Quality Audit Report

Hartfield Place, Swords Road, Whitehall, Dublin 9

Client:	AECOM
Document No:	220092-ORS-XX-XX-RP-7d-001

Revision	Status	Author:	Reviewed by:	Approved By:	Issue Date
P01	S2	TC	AP/JDK	DMcC	25/03/2022

Figure 3.9: Proposed Access Junction (Source: AECOM)

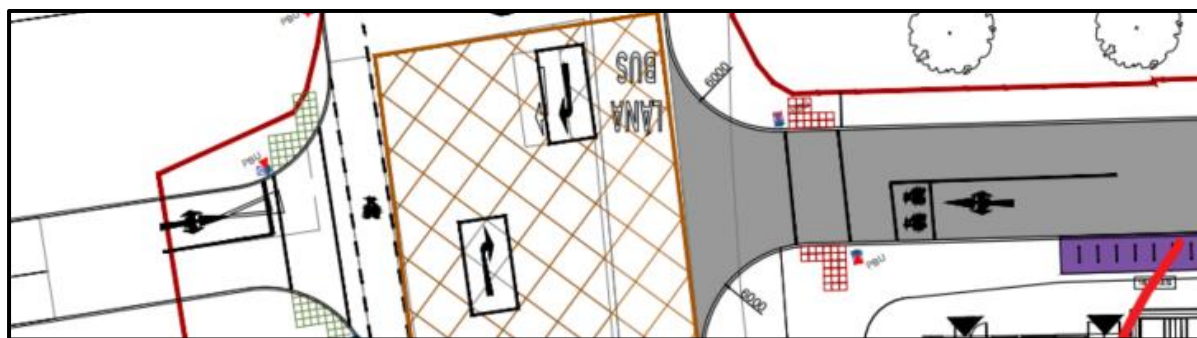
Issue 3.3: Incorrect Traffic Sign

The proposed Hartfield Place will upgrade the junction between Swords Road (N1) and Iveragh Road and it is proposed to install arrow road markings on all approaches to the junction. However, at both Iveragh Road and the site access road, the design team is proposing to install an incorrect road marking, with arrows indicating all 3No. directions, which is not in accordance with the Chapter 7 Road Markings.

Figure 3.10: Incorrect Disabled parking bay (Source: AECOM)

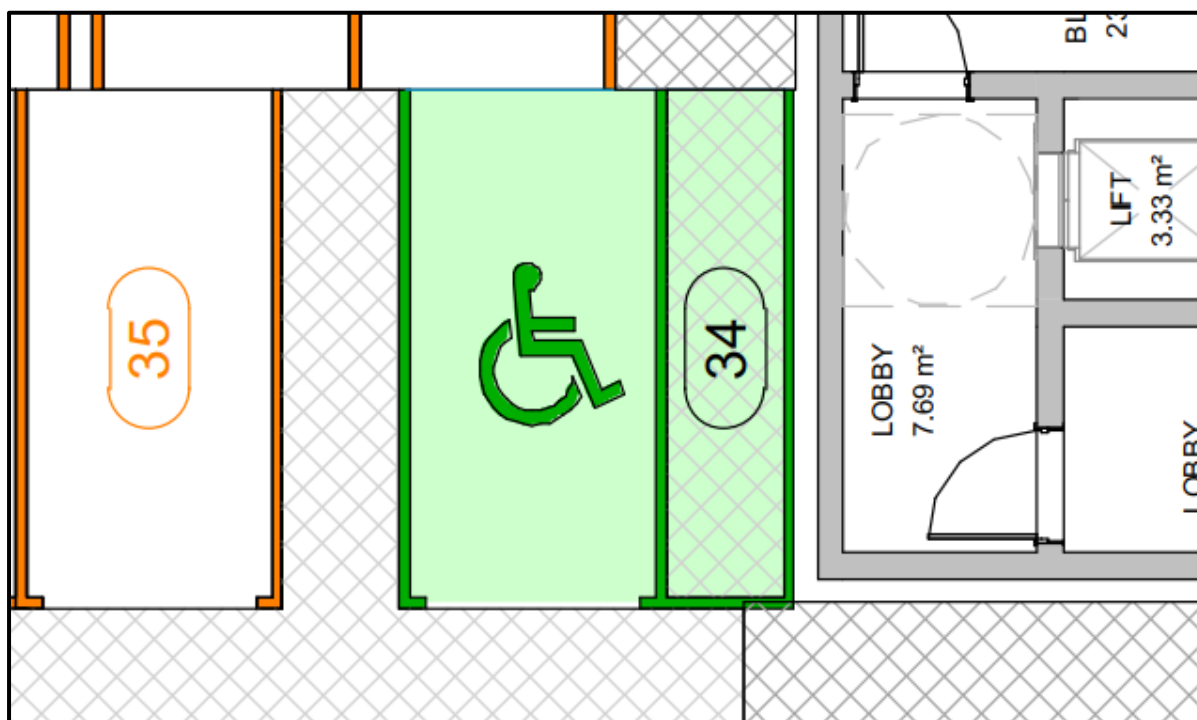
Issue 3.5: Disabled Parking Spaces (RRM 015)

It is intended to install 18No. disabled parking spaces at basement level, however, some of the proposed disabled parking bays are not compliant with DMURS and/or the Traffic Signs Manual. Disabled parking spaces should measure 6m in length and 2.4m in width, along with buffer zones with 1.2m to either side of the parking bay.

Figure 3.12: Proposed Crossing Points not in Accordance with Guidelines. (Source: AECOM)

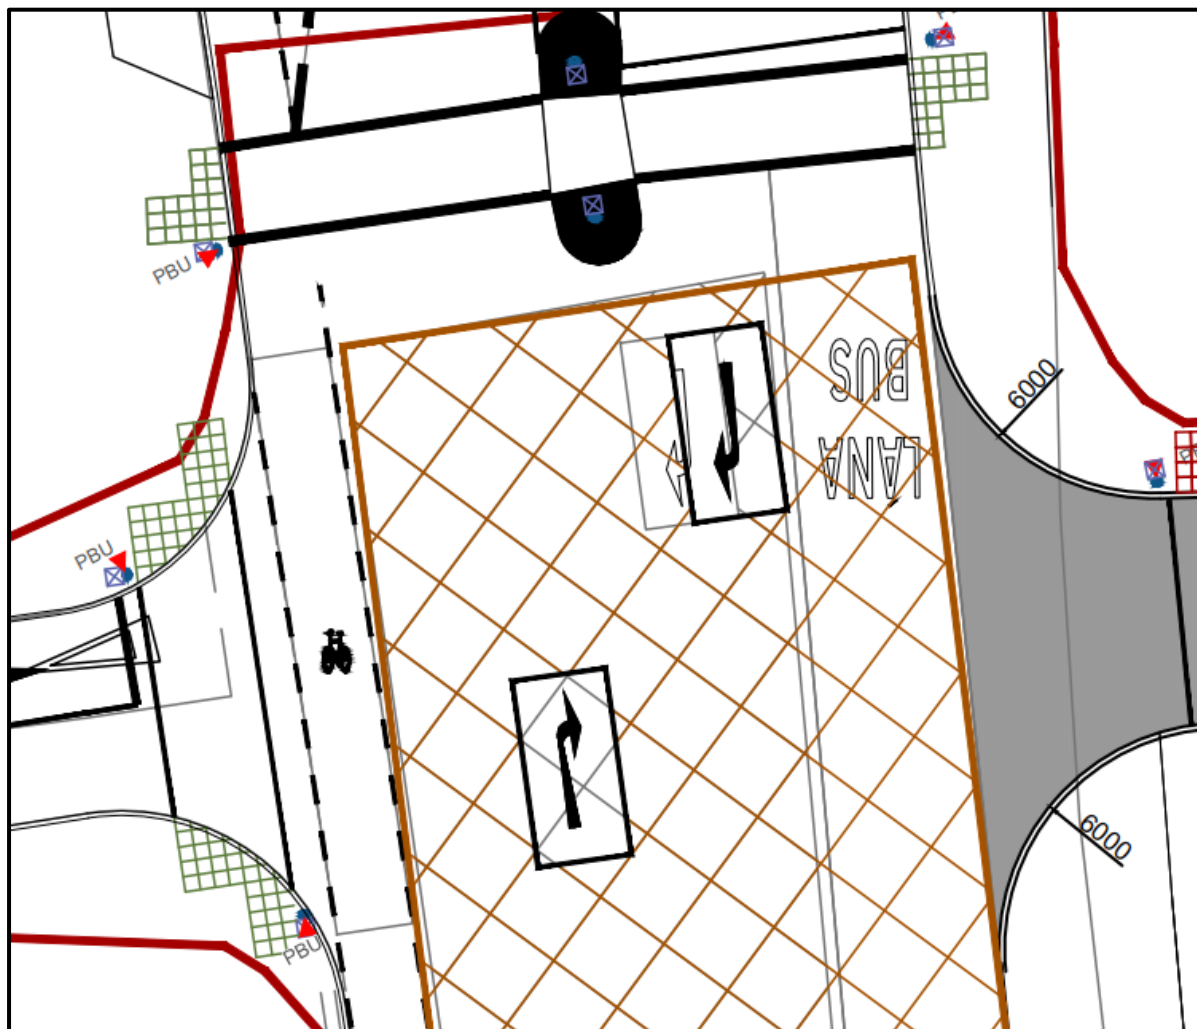
The proposed junction upgrade as part of the Hartfield Place proposal includes yellow tactile paving blister at the Iveragh Road and the northern approach of Swords Road to the junction,

which is not in accordance with DMURS and the TII document DN-GEO-03084, which states that for signalised crossing points, the tactile paving should be red.

The proposed signalised pedestrian crossing points should be reviewed in accordance with specifications in DMURS and the TII document DN-GEO-03084.

Figure 3.16: Signalised Pedestrian Crossing Points (Source: AECOM)

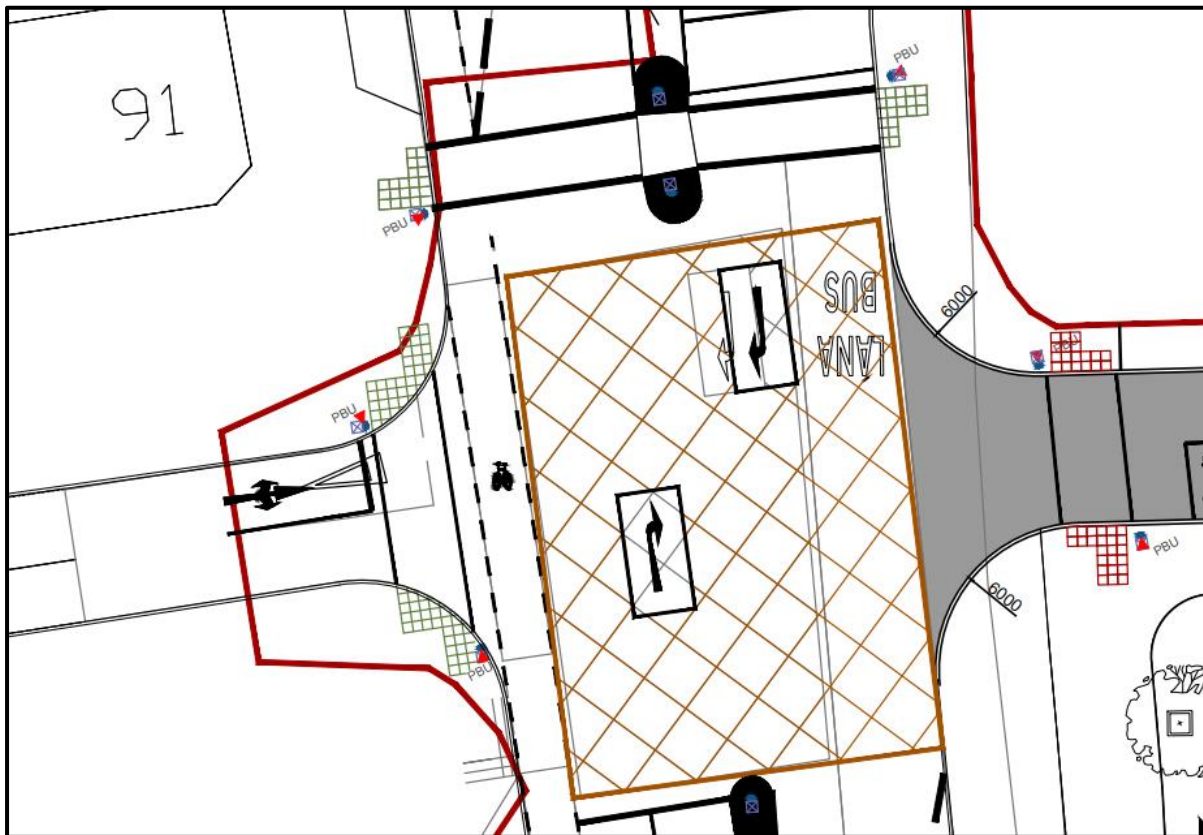
Issue 3.7: Signalised Pedestrian Crossings

As part of the proposals, it is intended to install and upgrade pedestrian traffic lights at the junction between Swords Road (N1) and Iveragh Road. The drawings provided show yellow tactile paving blisters at the crossing on the northern approach of Swords Road and at the Iveragh Road approach, however, for signalised pedestrian crossings, tactile blister paving should be red according to the TII document DN-GEO-03084 and DMURS. There is also a lack of information regarding the width of the crossing at all proposed crossing points.

The design team should review the site layouts and the LinSig analysis to match the proposals regarding pedestrian crossings. The design team should consider the inclusion of a pedestrian crossing point at the southern approach of Swords Road (N1) at the junction. The inclusion of a pedestrian crossing facility will increase pedestrian connectivity in the area and will reduce travel distance for pedestrians that wish to reach the other side of the road.

Figure 3.17: Overgrown Vegetation and Dirt at pedestrian crossing.

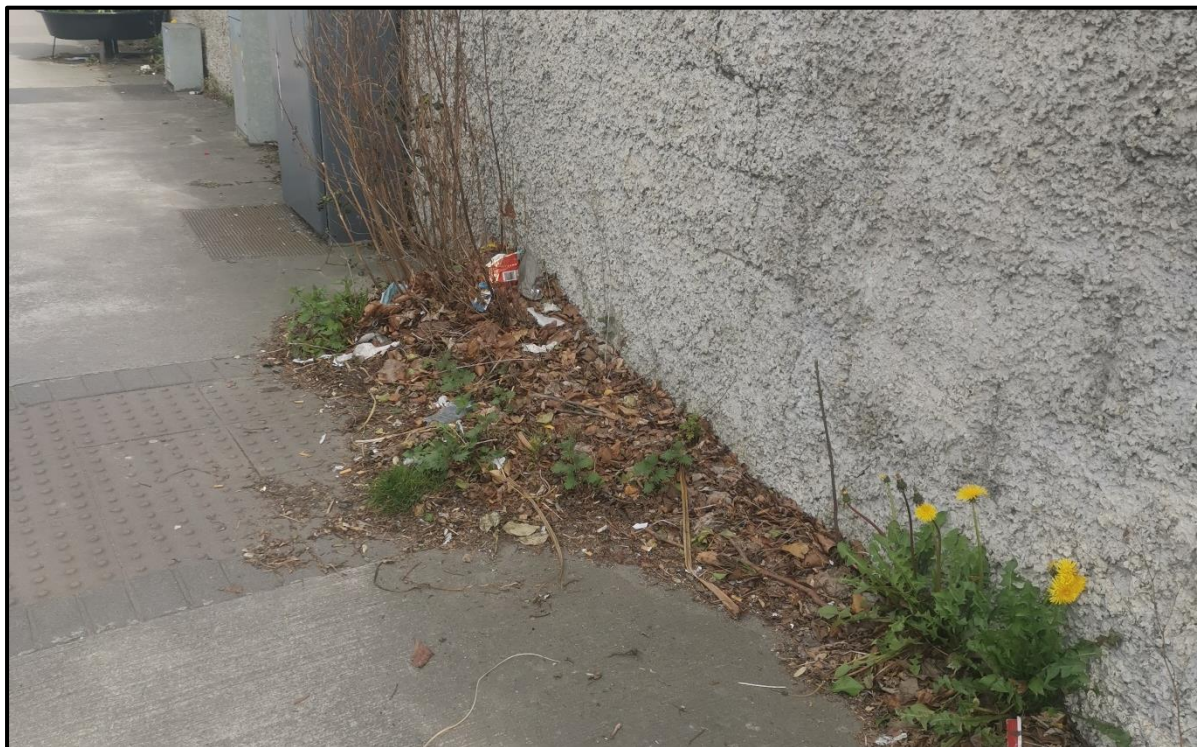
Issue 3.11: Overgrown Vegetation and Dry Leaves at end of Crossing Point

It was noted from the site visit that at the crossing point near the site entrance there is an accumulation of dry leaves, garbage and overgrown vegetation and the location is within the site boundary of the proposed development, however, there are no proposals to remove same

as part of the proposed works. This can cause risks of slips and falls for pedestrians and cyclists, especially vulnerable road users.

The design team should include in the proposals the removal of overgrown vegetation along the site boundary along Swords Road (N1) and at the pedestrian crossing to the north of the site entrance.

Problem No. 02: Signage & Road Markings

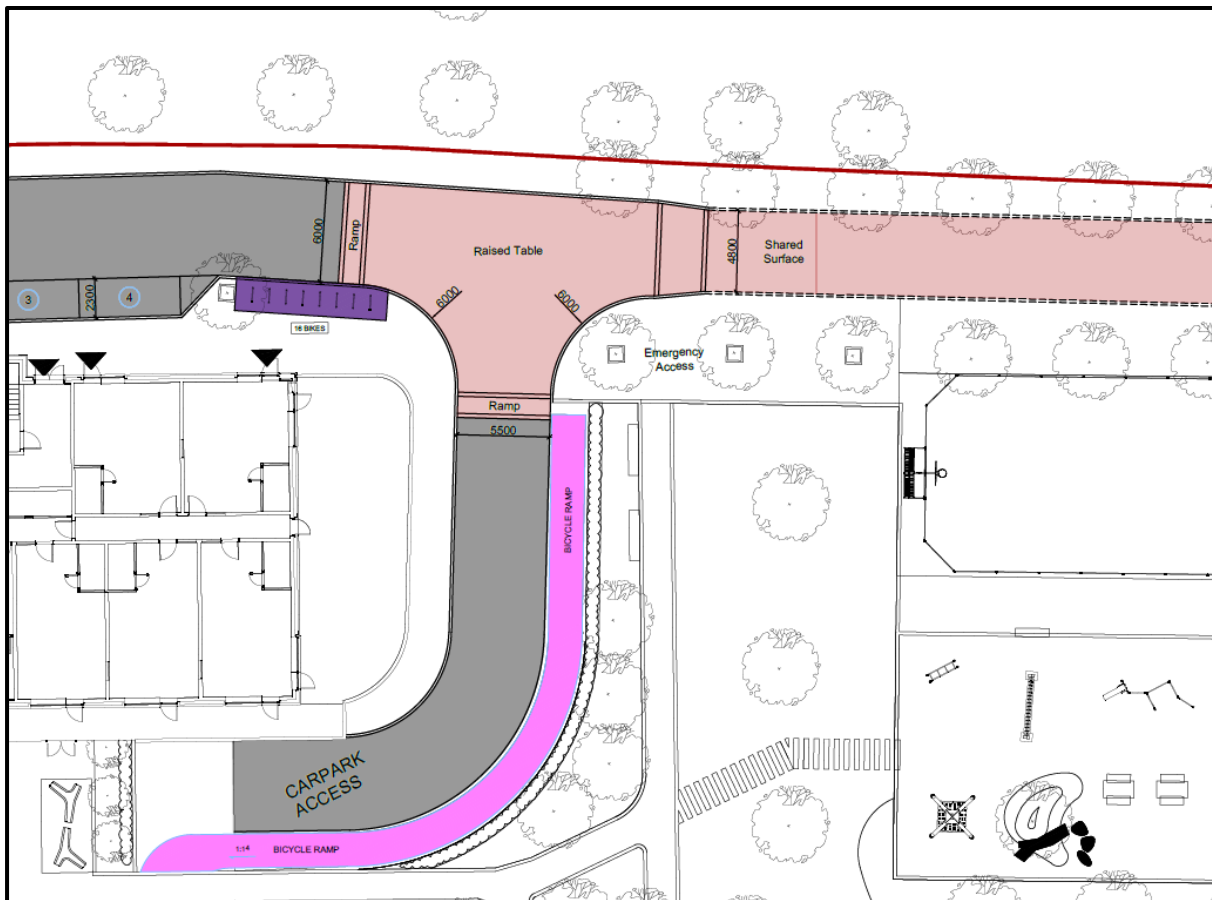
Location: Proposed Intersection and Internal Roads

The audit team note that there is a lack of signage and markings for the site access road and internal circulatory roads on the drawings provided. Signage and markings aid in informing road users of the presence of ramps, presence of vulnerable road users and stop/yield locations. Inadequate signage and road markings may lead road users not being alerted to the shared space which may result in vehicle-vehicle or vehicle-cycle conflicts causing injury.

The design team should include more details relating to signage and markings at the intersection and on the internal shared roadways in line with DMURS guidelines, the National Cycle Manual and the applicable Road Traffic Sign Manual.

Problem No.03: Shared Surface Demarcation

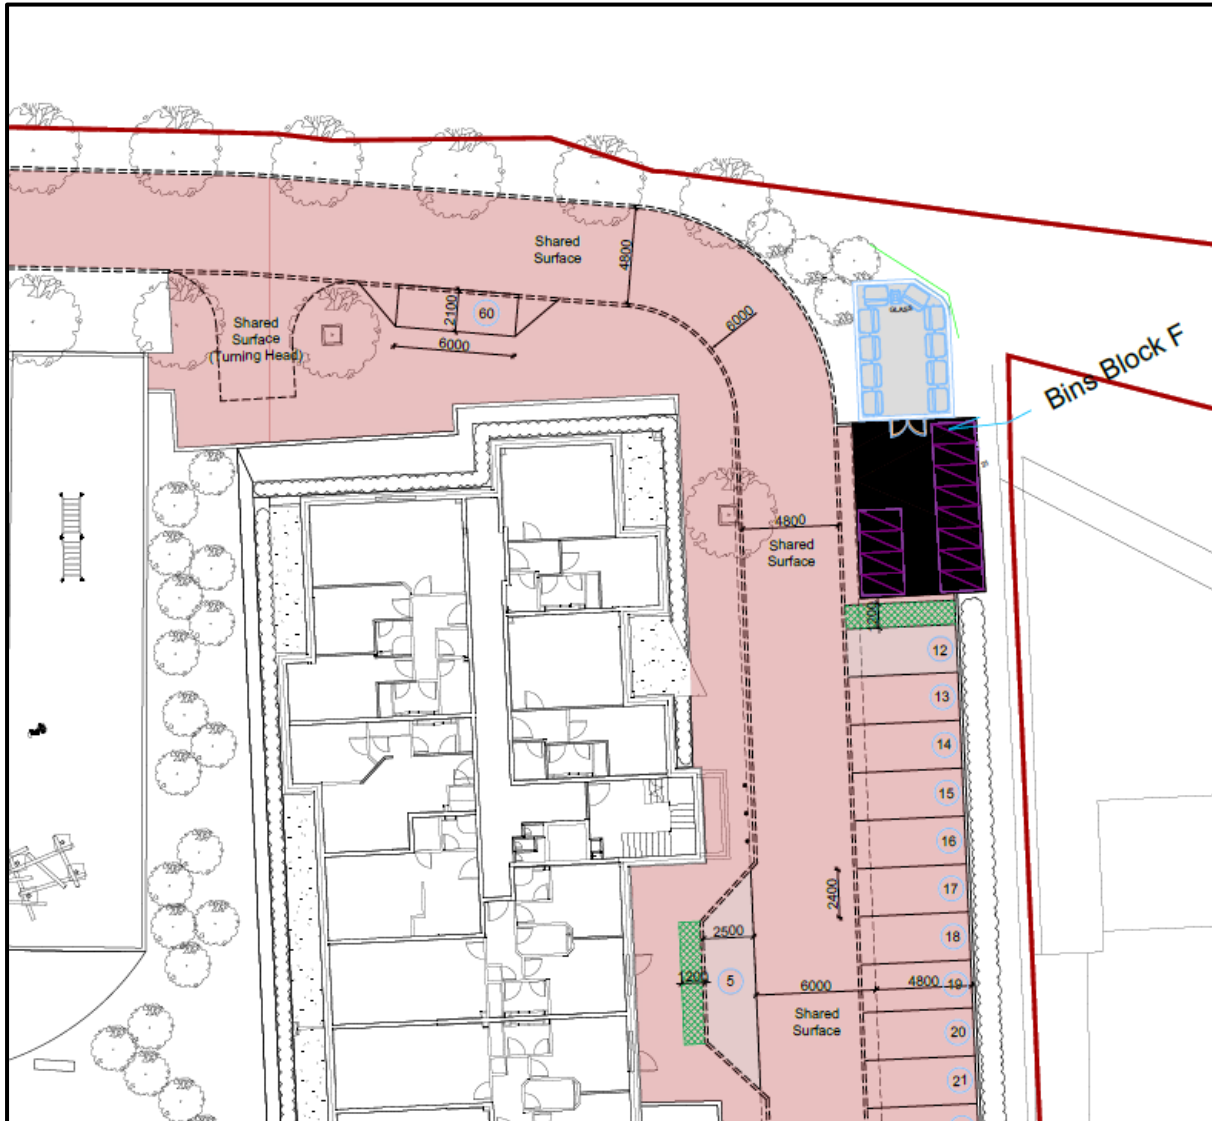
Location: Internal Road network

The audit team note from the drawings provided that there is a lack of information relating to the surface treatment for shared surfaces. Road users need to be made aware of the presence of vulnerable road users in the vicinity of shared surfaces by means of pavement colour treatment, textures and/or signage.

The design team should ensure that appropriate shared surface demarcation and signage provided for throughout the site to clearly distinguish the proposed use in accordance with DMURS guidelines.

Problem No.04: Pedestrian Disabled Access

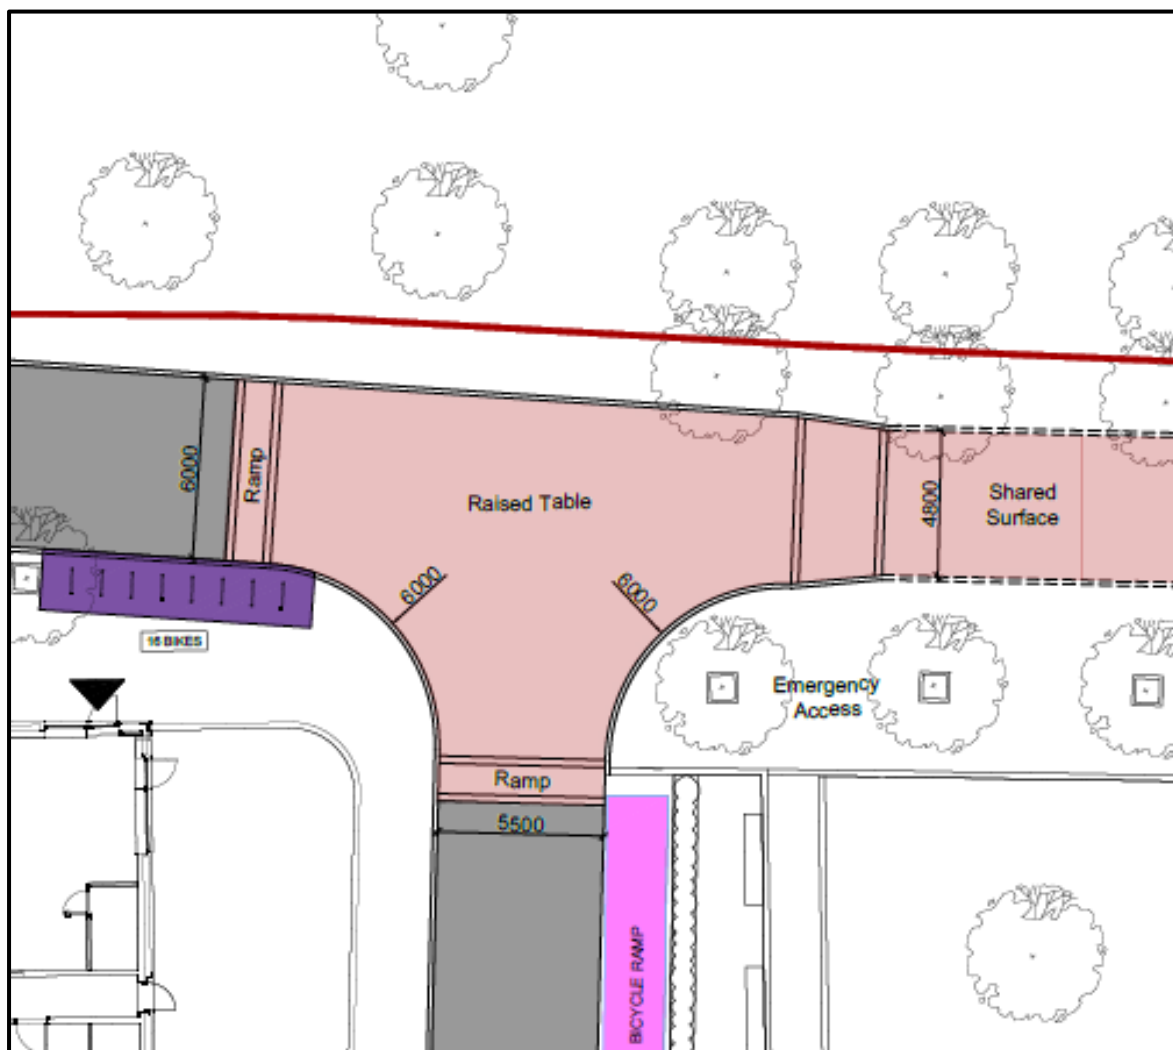
Location: Raised Platform

The audit team note that drop kerbs and tactile paving is not identified at the internal junction. These facilities aid users with specific visual needs in particular and the omission of same at crossing locations may will require vulnerable road users to travel in the roadway putting them at risk with vehicle conflicts and injury.

The design team should ensure that details and locations of 'drop kerbs' and tactile paving is provided throughout the scheme at proposed crossing points.

Problem No.05: Bicycle Ramp Width

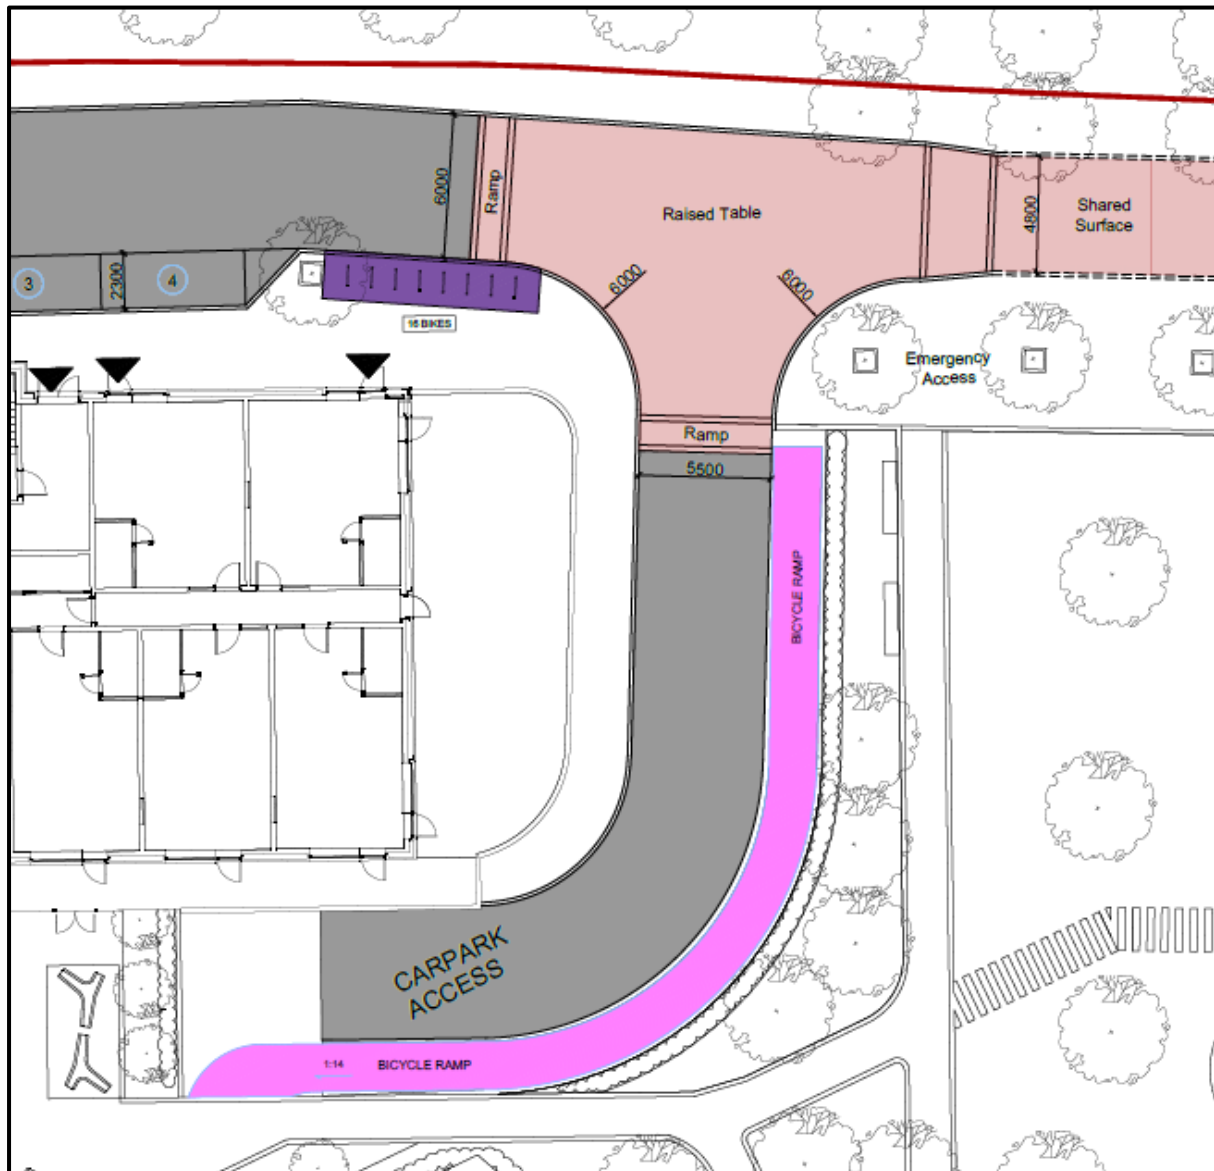
Location: Underground Carpark Access Ramp

The audit team note from the drawings provided that there is a bidirectional cycle path specified next to the vehicle access ramp. It is not clear from the drawing if the width is sufficient to allow two bicycles to pass and if cyclists are required to dismount in order to safely merge with vehicle traffic on the shared surface.

The design team should assess the ramp cycle path width and clarify the merge and diverge manoeuvres from the shared path to the ramp in the vicinity of the internal junction.
